BIDDING AND CONTRACT REQUIREMENTS
ADDENDUM NUMBER 01

Date: 8/14/2026

Architect's Project Number:
226057.00

Re: **Addendum Number 01 to the bidding documents for:**
Moline-Coal Valley School District
Moline High School – Baseball & Softball Complex Renovation

CIVIL SITE PLAN

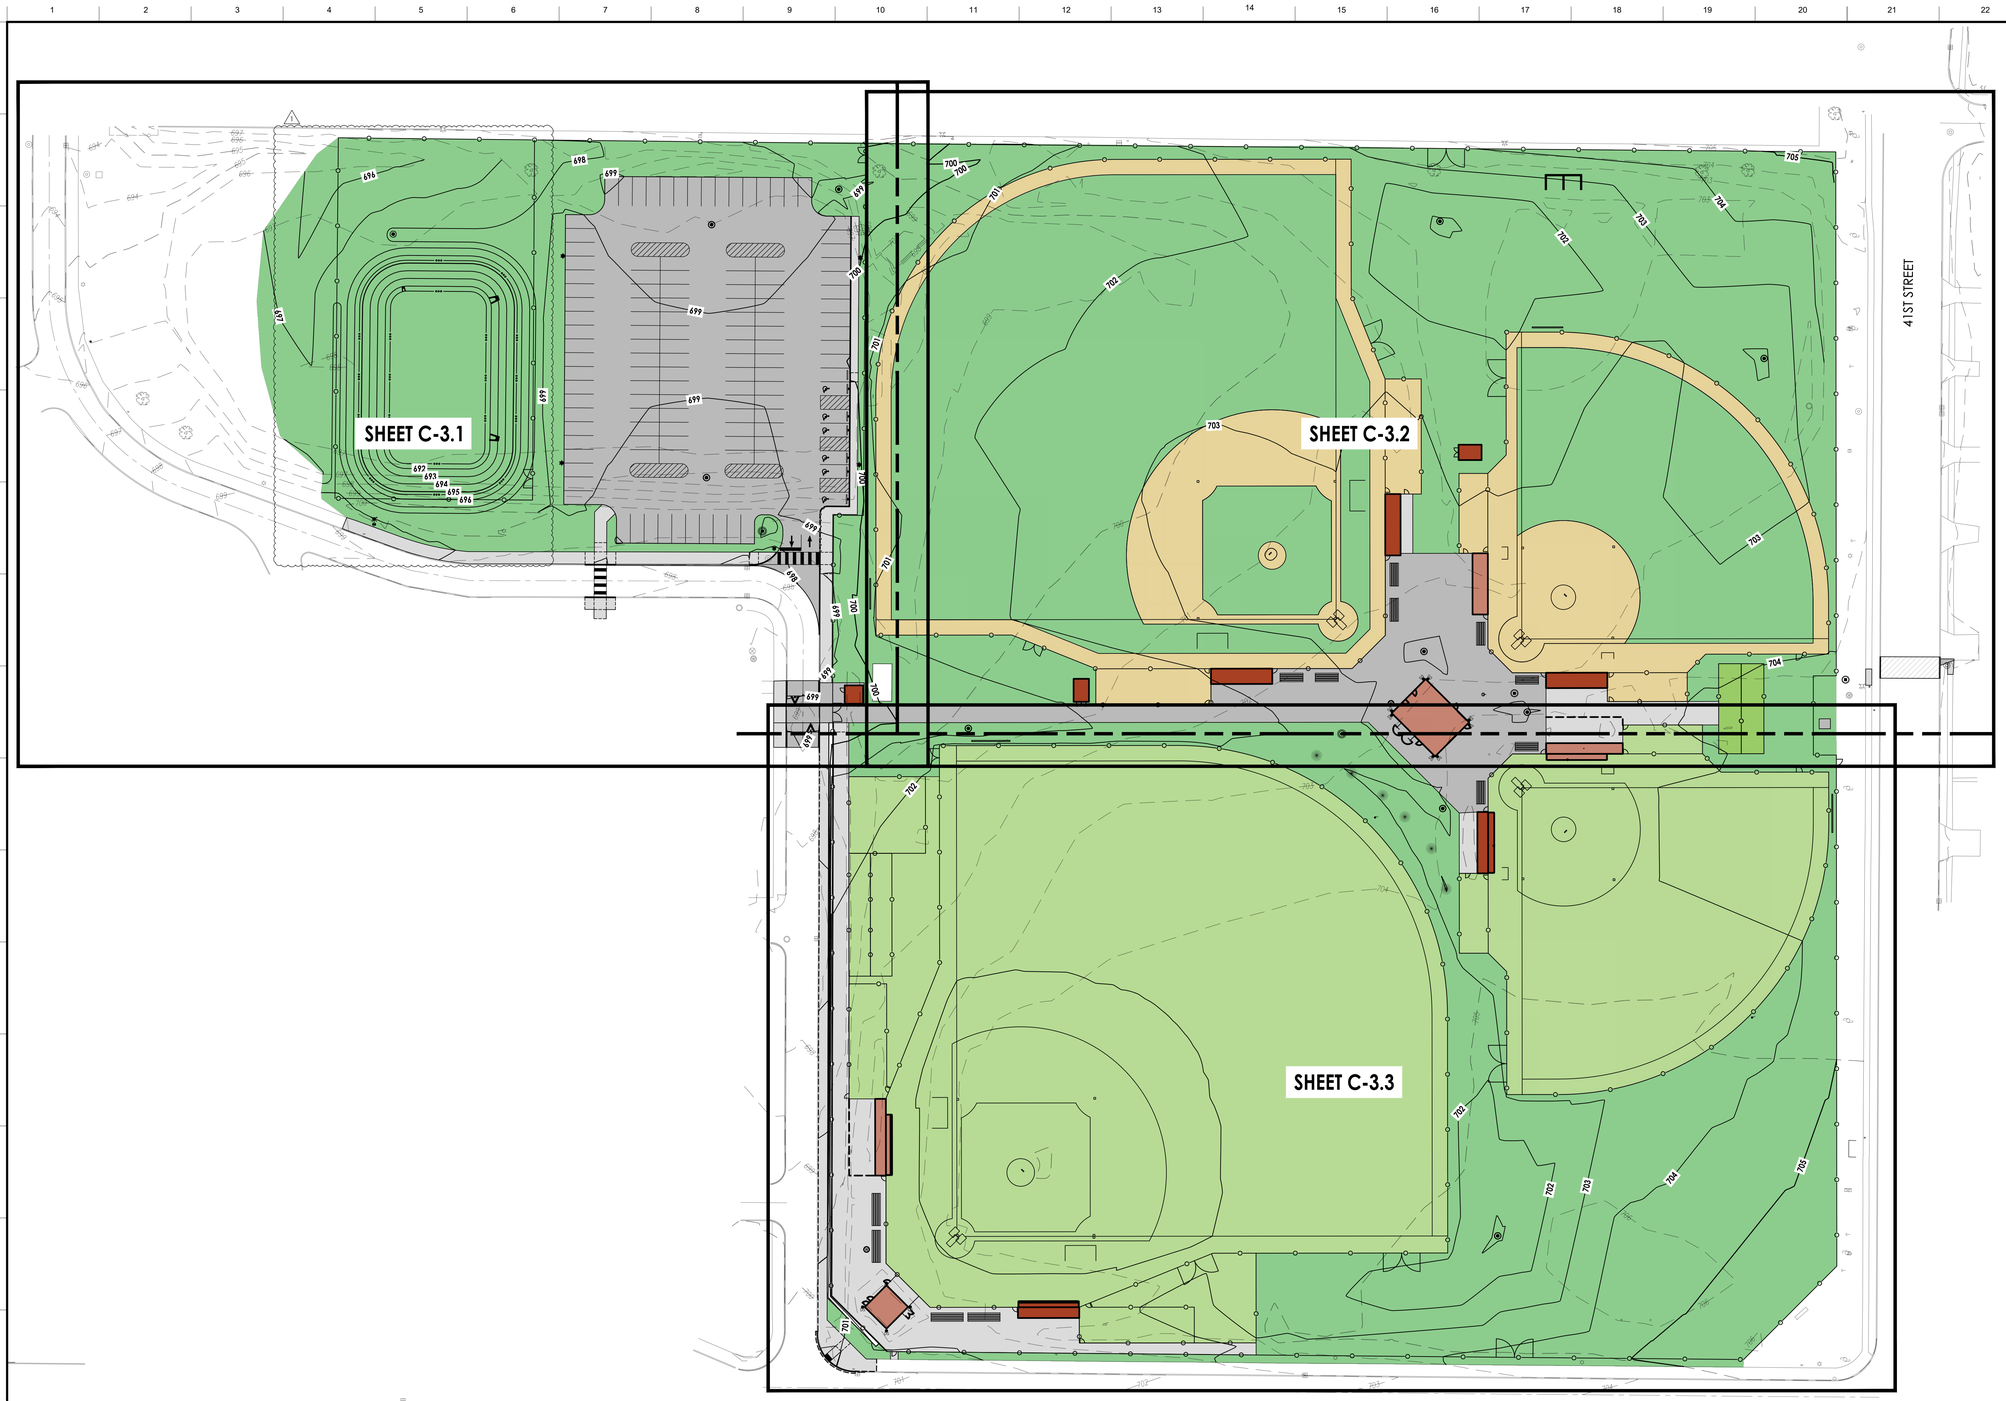
8/12/2026	12	Bush Construction	On drawing C3.2 close to the top of the page there is this note and drawing on the concrete bin block system. Could you please help us with the scope on this? Are these the lego style concrete blocks? How high do you want the walls to be? Does this need to have concrete support below it or do they just sit on the ground?	1	Correct, these are the lego style concrete blocks. The walls should be two blocks high, so 48" tall. No concrete support below is required as they will just sit on the ground.
8/12/2026	13	Bush Construction	Are all inspections by the ROE? Does that mean that we are not to include any costs for permitting?	1	Yes, all inspections are by the ROE and the State Plumbing Inspector. No costs for building permitting are to be included in the bid.
8/12/2026	14	Bush Construction	Do we have any responsibility for permit and or costs for the site such as NPDES or Cosesco permits?	1	Yes, the GC or applicable subcontractor are required for permitting for the site for the NPDES and SWPPP. The documents for these permits will be provided by the design team.

1 P-101 PLUMBING PLANS - CONCESSION BUILDING - DOMESTIC WATER
1/4" = 1'-0"

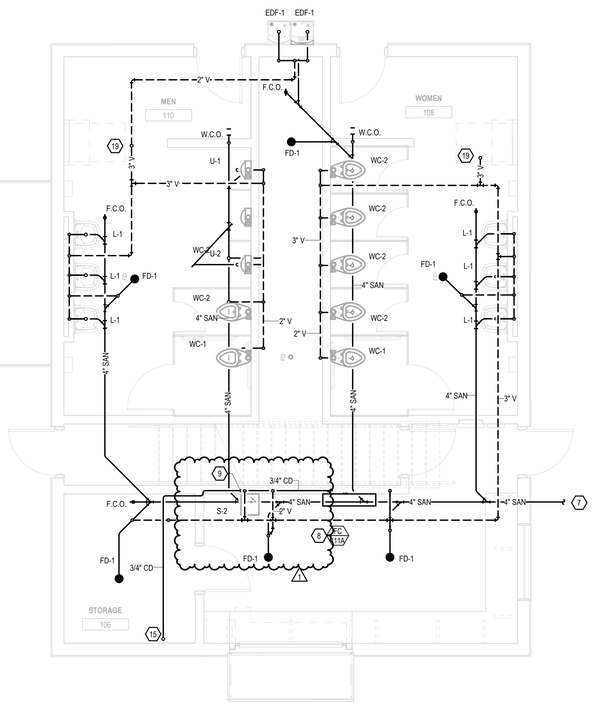
I. Drawing P-101, titled, PLUMBING PLANS – CONCESSIONS BUILDING.
   1. At Drawing 1, titled, PLUMBING PLANS – CONCESSIONS BUILDING – DOMESTIC WATER:
      a. **REVISE** location of S-2.
   2. At Drawing 2, titled, PLUMBING PLANS – CONCESSIONS BUILDING – SANITARY AND VENT:
      a. **REVISE** location of S-2.

1 E-101 ELECTRIAL FIRST FLOOR PLAN - CONCESSION BUILDING

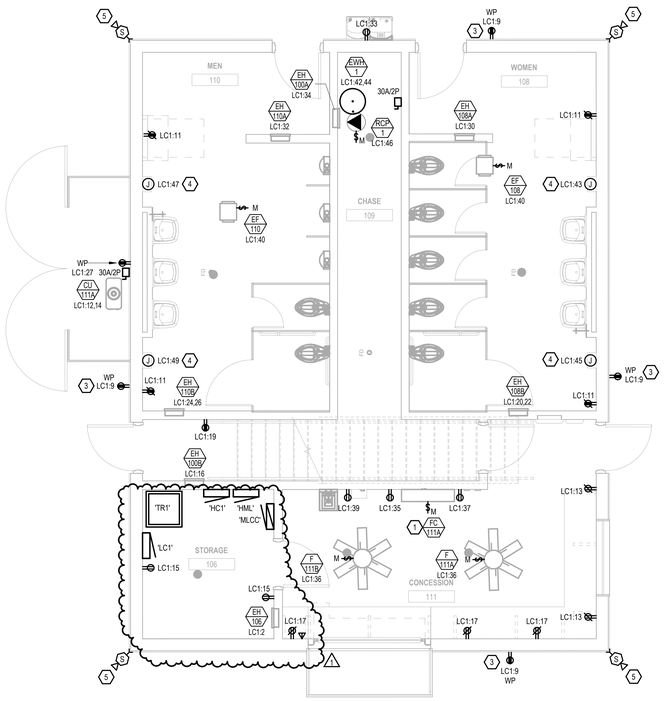
N. Drawing E-101, titled, ELECTRICAL PLANS – CONCESSIONS BUILDING.
   1. At KEYNOTES:
      a. **ADD** note 6.
   2. At Drawing 1:
      a. **ADD** above counter data outlet in Concession 111.
      b. **REVISE** equipment layout in Storage 106.
   3. At Drawing 2:
      a. **REVISE** equipment layout in Storage 106.
   4. At Drawing 3:
      a. **ADD** wireless access point.
      b. **ADD** junction box at each desk (3 total).

1 E-103 — ELECTRIAL FIRST FLOOR PLAN - CONCESSION BUILDING VARSITY BASEBALL

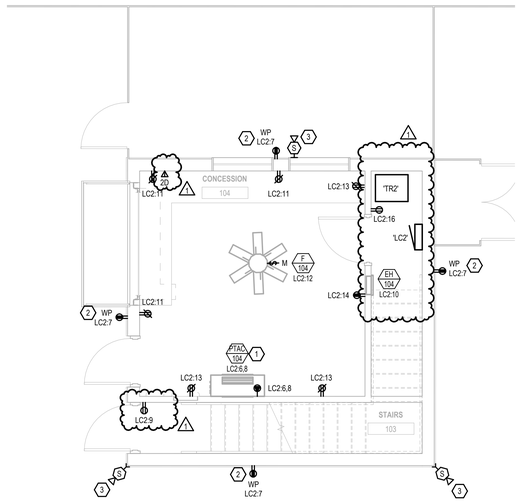
O. Drawing E-103, titled, ELECTRICAL PLANS – CONCESSIONS BUILDING VARSITY BASEBALL.
   1. At KEYNOTES:
      a. **ADD** note 4.
   2. At Drawing 1:
      a. **REVISE** equipment layout.

b. **ADD** above counter data outlet in Concession 104.
c. **ADD** power to EH-104.

2 E-103 — ELECTRICAL FIRST FLOOR LIGHTING PLAN - CONCESSIONS BUILDING VARSITY BASEBALL

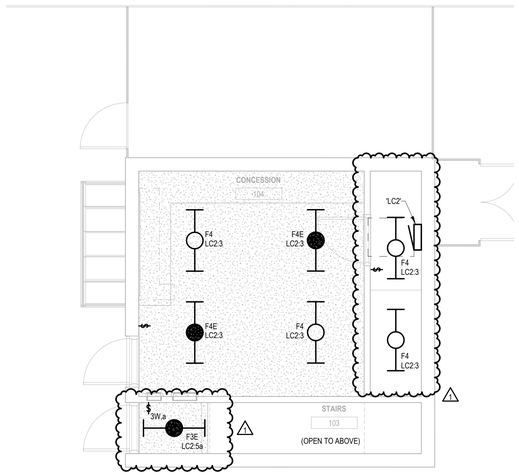
3. At Drawing 2:
   a. **REVISE** equipment layout.
   b. **REVISE** switch location.
   c. **ADD** lighting and switch in storage closet.
4. At Drawing 3:
   a. **ADD** wireless access point.
   b. **ADD** junction box at the desk.
